Request for Class II Permissive Change(C2PC)

FCC ID: VG8EM025FXXXV2

Date: 2024-03-04

1. Difference in appearance & construction & PCB:

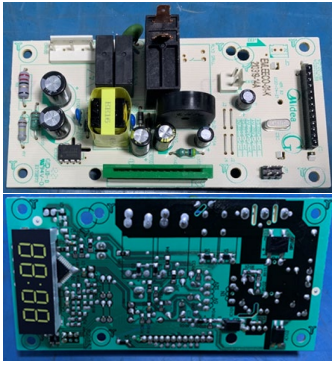
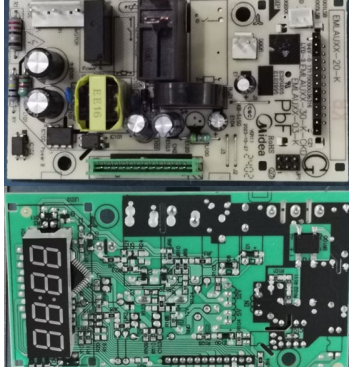
No.:	Original	New	Difference(s)
1	 <p>半透明烟灰色</p> <p>Color palette: Black, Pantone cool Gray 6C, Pantone 199c, Pantone 299c</p>	 <p>半透明烟灰色视窗, 透光度: 14% ± 4%</p> <p>Color palette: Black, Pantone Cool Gray 6 C, Pantone 199 C, Pantone 299 C</p>	Keypad: Updated front keypad to accommodate child lock function (Child resistant oven door function).
2			Mother board: Modified the peripheral circuit (non-RF circuit) and some individual components and PCB layout. The magnetron and other circuit are exactly same as before.
3	Not Applicable		The new one adds a solenoid valve locking mechanism, the original is not.
